# Vieux Carré Commission Architecture Committee Meeting

Tuesday, January 24, 2023

**816 St Philip**

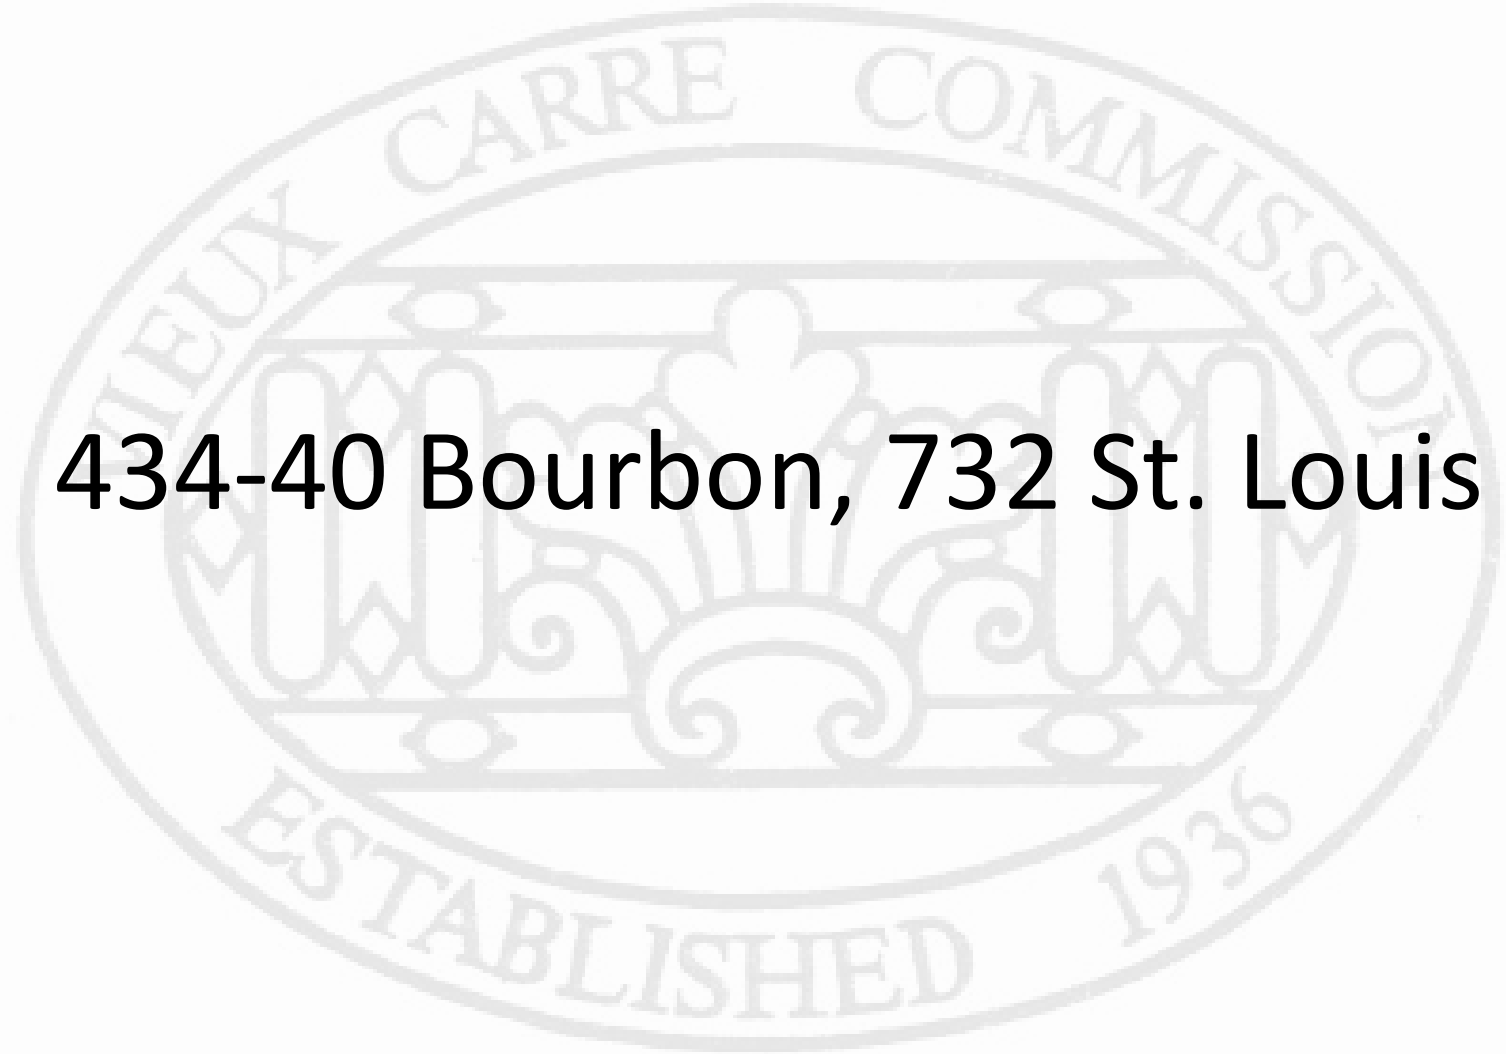
The applicant has submitted a copy of the previously reviewed architectural drawings, which have now been stamped by the consulting engineer. Staff remains concerned that this detail, particularly the beaded trim applied to the bottom of the sistered joists, may deteriorate quickly due to the thinness of this material, and seeks the guidance of the Committee regarding the proposed reinforcement.
